**TO: PLANNING COMMISSION**

**SUBJECT: APPEAL OF PLANNING ADMINISTRATOR'S DECISION APPROVING TENTATIVE SUBDIVISION / CLASS 2 ZONING ADJUSTMENT PERMIT CASE NO. 21-05 FOR PROPERTY LOCATED AT 2230 DOAKS FERRY ROAD - 97304**

Should the Planning Commission affirm, modify, or reverse the Planning Administrator's approval of a Tentative Subdivision and Class 2 Zoning Adjustment for Case No. SUB-ADJ-21-05 to allow a 27 lot subdivision with an alternative street standard to allow the grade of Buzz Street to exceed 12%, exceed the 600-foot maximum block length and to reduce the street width from 60-feet to 50-feet and a Class 2 Adjustments to exceed the maximum lot width to depth of 300 percent to 500 percent for Lot 12 and to allow Lot 3 to reduce the minimum lot depth for a double frontage lot from 120 feet to 112 feet, for property approximately nine acres in size and zoned RA (Residential Agriculture).

Figure 5: Map showing Tributary B

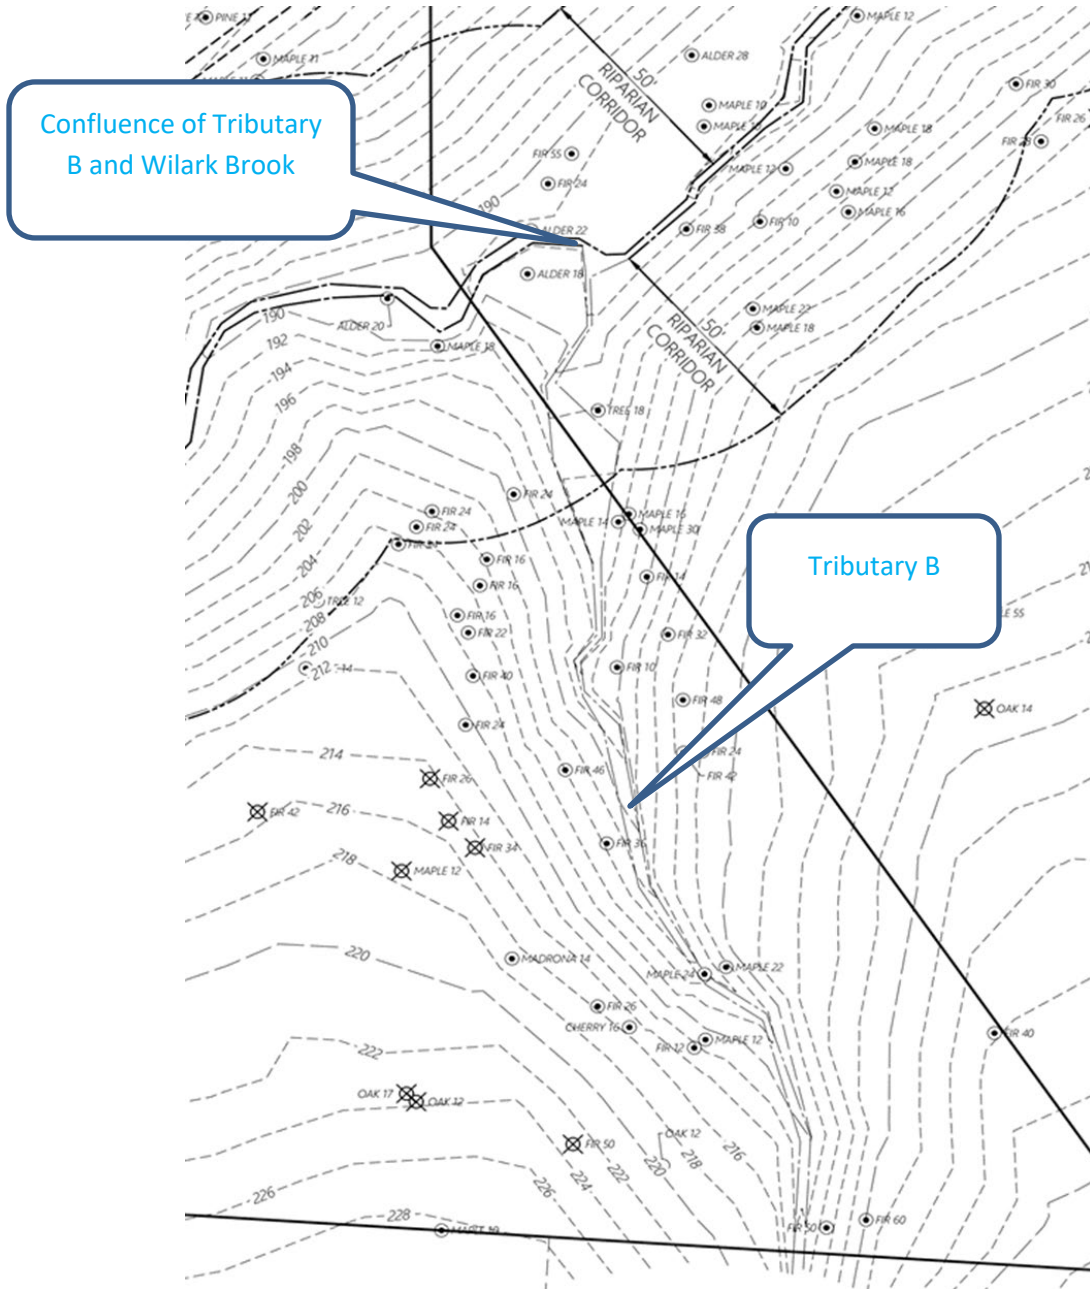
These two existing streams are not identified in the application. The designation of these streams and their 50-foot riparian corridors should be identified under the provisions SRC Chapter 808 and appropriate provisions made for their protection.

**Staff Response:** The application addresses the only tributary stream identified on the Local Wetland Inventory, Wilark Brook. The applicant is required to have a permit from the Department of State Land, which requires a delineation of the subject property. If the delineation identifies waterways and wetlands that would be impacted by the proposed development, they may need to redesign the subdivision to comply with state and federal permits and/or obtain a Tree Removal Permit for any additional vegetation and/or trees needed to be removed within 50-feet of delineated waterway.

Figure 7: Habitat Tree in the Riparian Corridor of Tributary B (photo 6/9/2021)

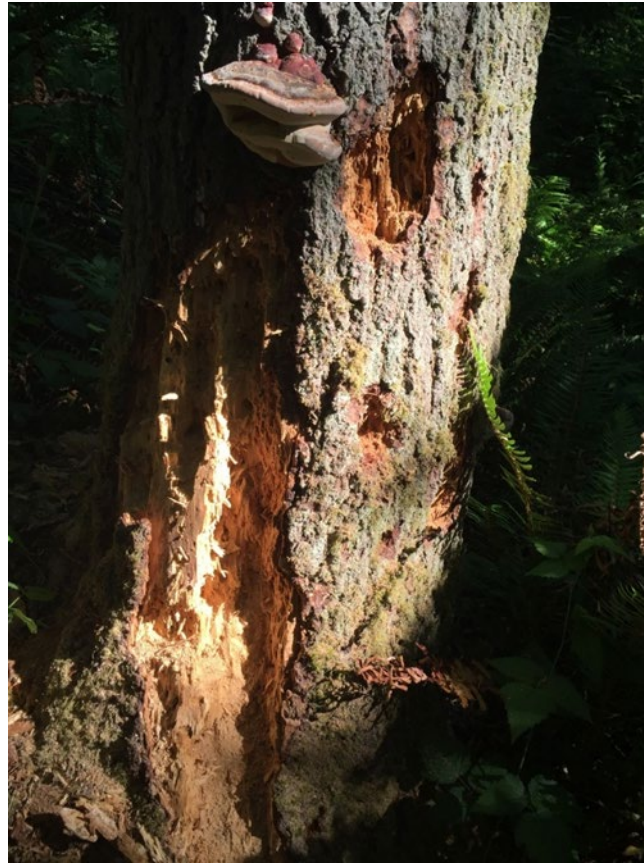
Other wildlife habitat values include the riparian cover to the tributary streams that help to maintain cool water in Wilark Brook and associated wildlife habitat such as the snag (Figure 7) providing habitat for cavity nesting birds and animals.

**Staff Response:** The waterway 'Wilark Brook' is regulated by State and Federal agencies, and native fish, including native Cutthroat trout and Sculpin are overseen by Oregon Department of Fish and Wildlife. The proposal is not building within the waterway and the Salem Revised Code does not restrict development within the riparian area. Appropriate State and Federal permits required for the applicant to obtain will address habitat of Wilark Brook.

**Proposed Finding.** As noted in the decision, no portion of the site has been identified as a significant wildlife habitat by state wildlife management agencies or the city. The subject properties located within the urban growth boundary, and incorporated within the city limits of Salem, and is designated in the City of Salem Comprehensive Plan as single-family residential. Designation as single-family residential anticipates existing or future residential development similar to subdivision proposed by the applicant. Loss of wildlife habitat that has not been identify as significant is not a criteria under Salem Revised Code for granting or denying a phase tentative plan subdivision approval. Further, SRC Chapter 809, ties evaluation of wetlands for significance to, in part, indigenous salmonids “which are listed as sensitive threatened or endangered by a federal or state authority.” Appellants concede cutthroat trout and sculpin are not listed as threatened or endangered. Accordingly, there is no indication of any significant habitat present on site or of any impact to any identified habitat.
